FROM: Carolina Power & Light Company Raleigh, North Carolina 27602 N. B. Bessac		DATE OF DOC 7-6-73	DATE REC'D 7 11-73	LTR	MEMO	RPT	OTHER FACSIMILE
TO: R. J. Schemel		ORIG 1	CC	OTHER	SENT AEC PDR X SENT LOCAL PDR X		
CLASS	UNCLASS XXX	PROP INFO	INPUT	NO CYS REC'D 1	DOCKET NO: 50-261

PLANT NAME: H. B. Robinson, Unit # 2

**H. B. ROBINSON UNIT NO. 2
LICENSE DPR-23, DOCKET NO. 50-261
ADDITIONAL INFORMATION IN SUPPORT OF
100% THERMAL POWER AUTHORIZATION**

FIGURE 14

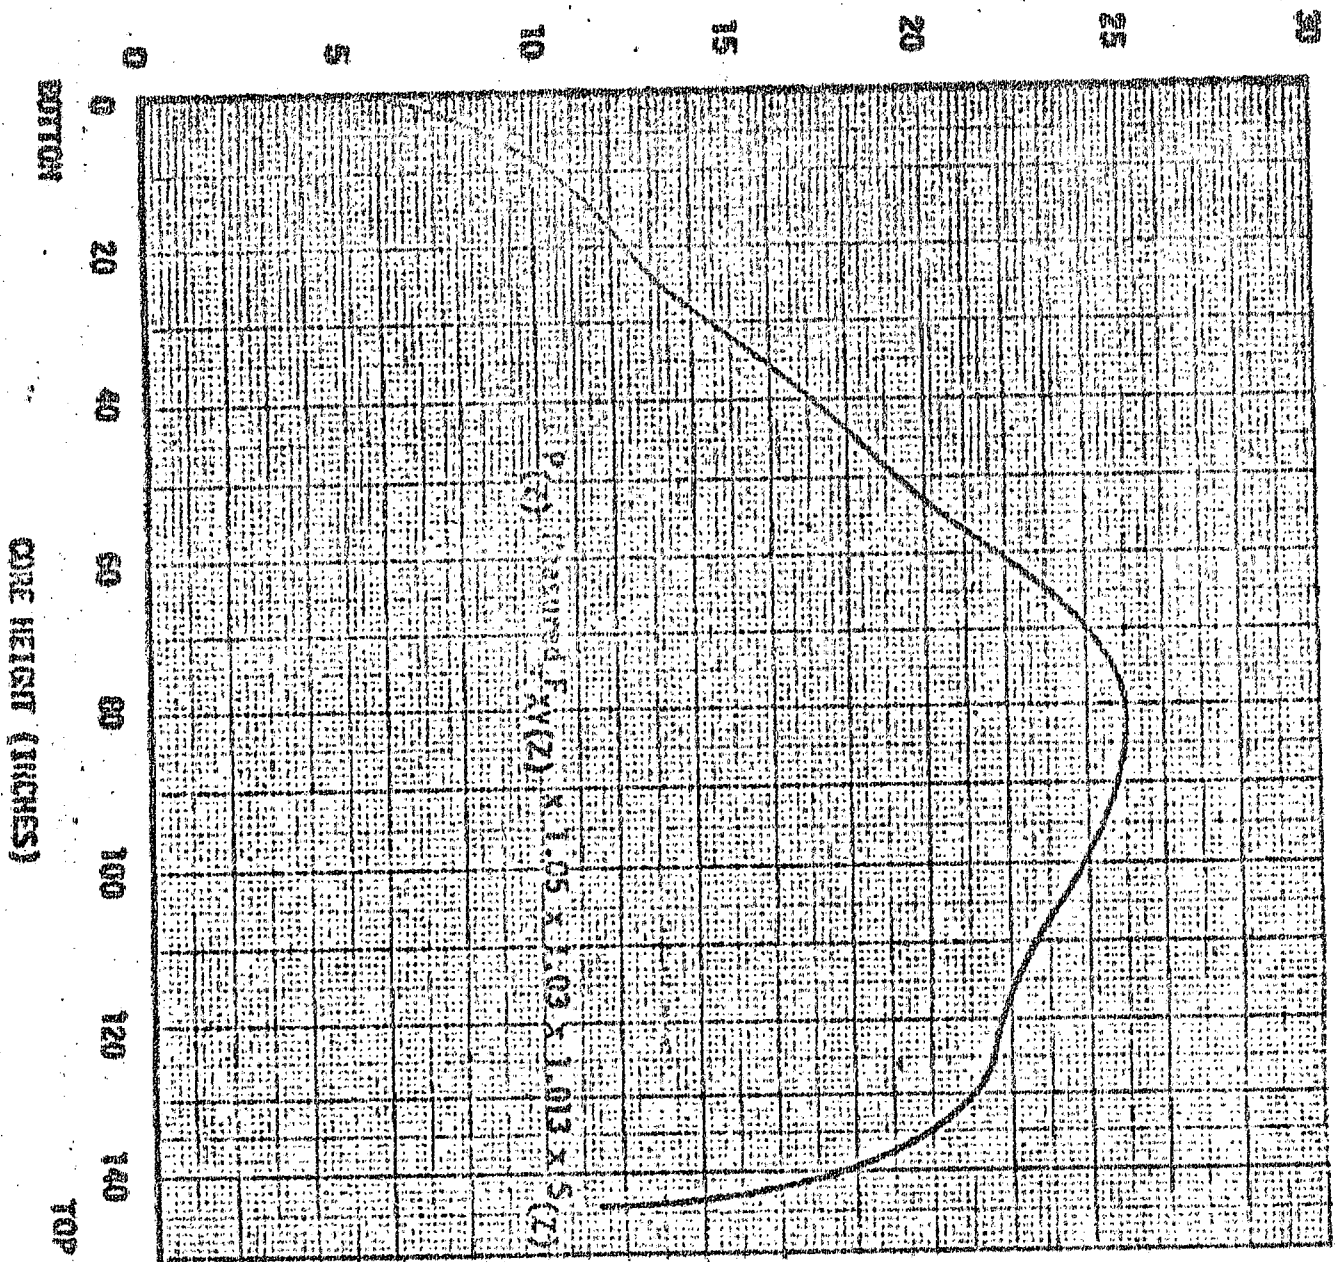
1. Additional analyses have been performed to evaluate the consequences for a LOCA during Cycle 2 operation for various axial power shapes. Specifically, analysis has been performed for an axial power shape representing the "corner point" on the F_q versus axial offset flyspeck plot (refer to Figure 4.2 of WCAP-8114), i.e., at the axial offset value beyond which a power reduction is required by the Technical Specification.

The power shape analyzed is shown on Figure 1 as a plot of F_q versus core height. As shown on the figure, allowances have been made for the effect of pellet density variations (1.013) and the power spike penalty appropriate to a region with flattened clad sections. Additionally, the measured values for the radial peaking factor, F_{xy} , as a function of axial height have been included in this figure. The peak linear rod power corresponding to this power shape is 13.8 kw/ft.

FIGURE 2

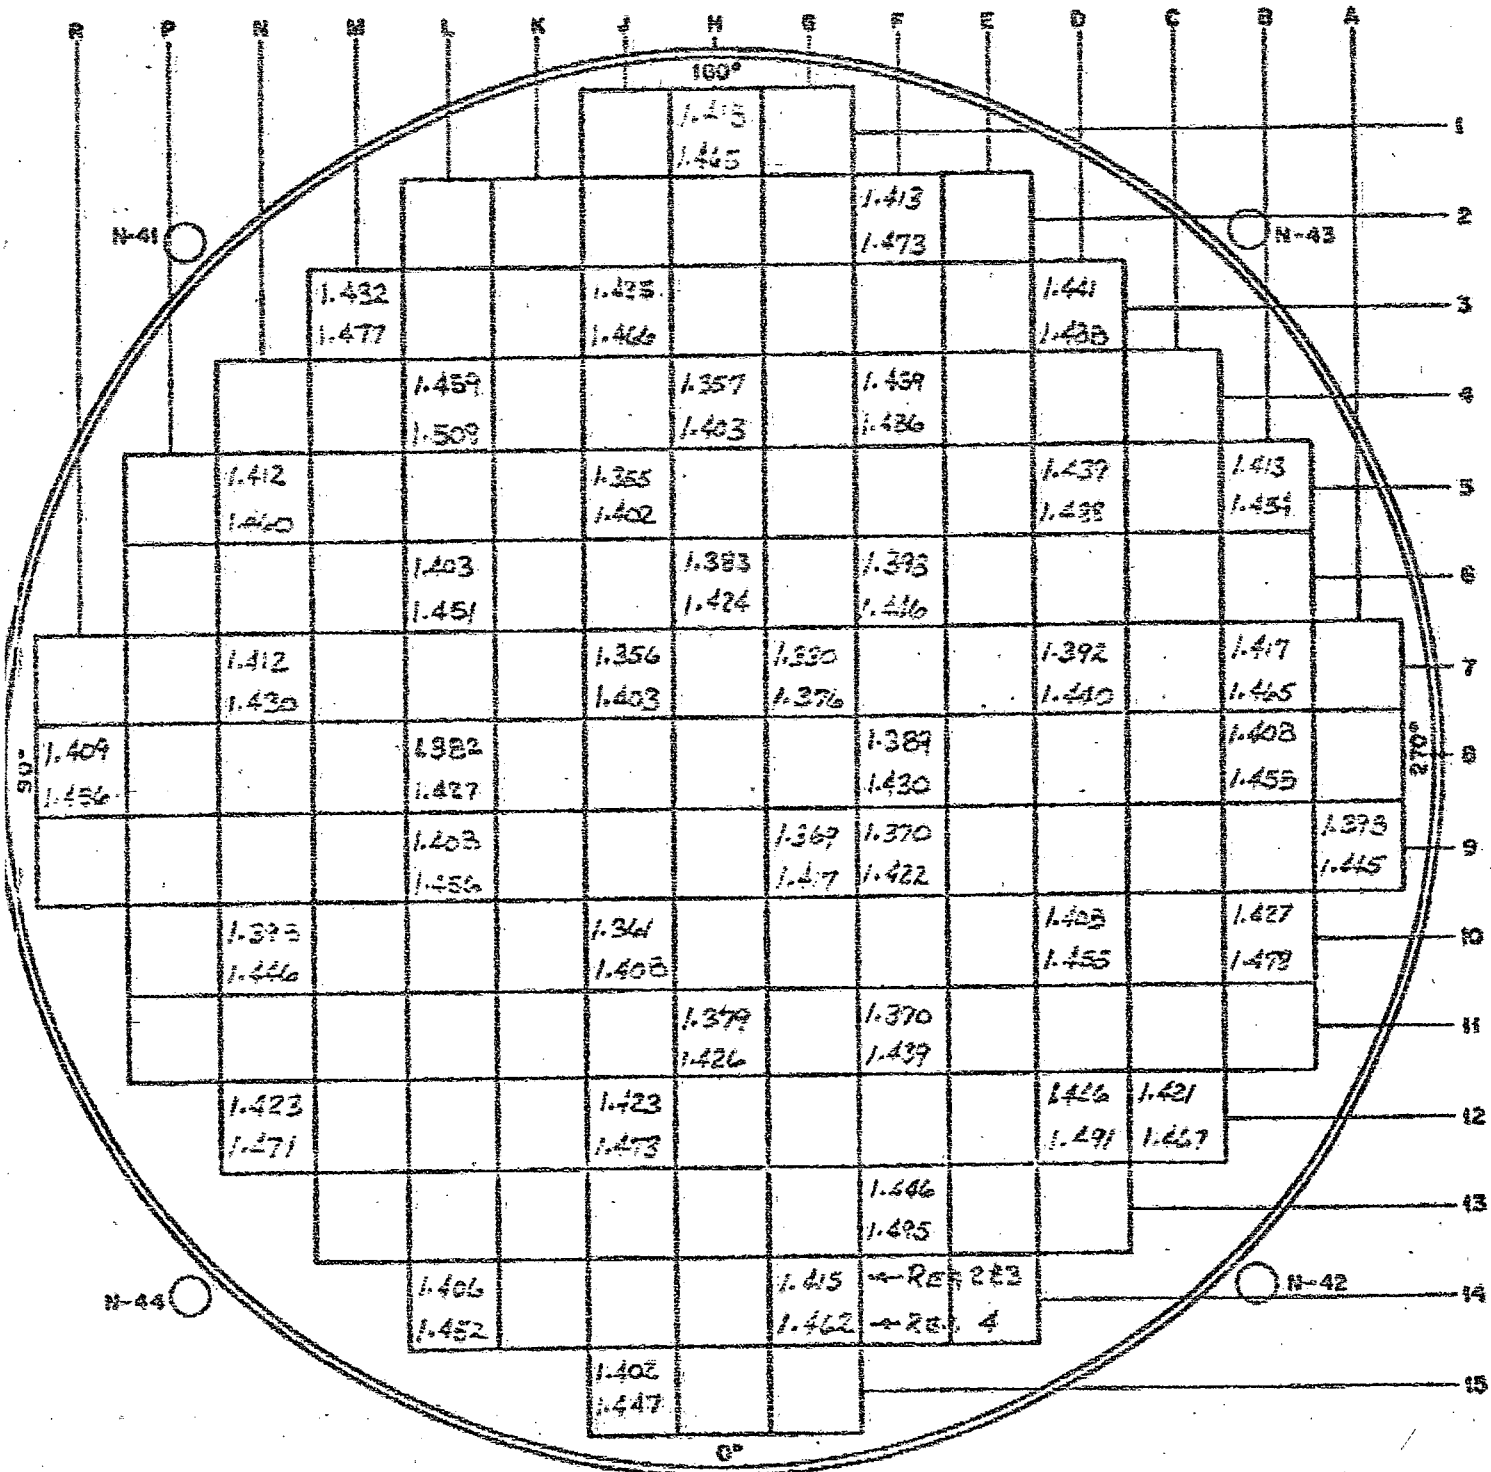
4. The methodology for determining hot channel factors F_N from monitoring F_2 in selected assemblies has been applied to the first seven full in-core power maps acquired during Cycle 2 operations of the H. B. Robinson Unit. The specific operational conditions under which these maps were obtained are summarized in Table 1 below.

Values of \bar{K} , the factor relating a specific thimble F_z , S to the region F_N and the associated standard deviation for each \bar{K} were determined and are illustrated in Figures 2 and 3. The values of \bar{K} presented shall serve as the initial values for the conduct of the surveillance program subject to the continued accuracy conditions set forth in 3 above. Likewise the standard deviations contained in Figure 3 serve as the initial bases for thimble selection and the associated uncertainty to be used during surveillance.
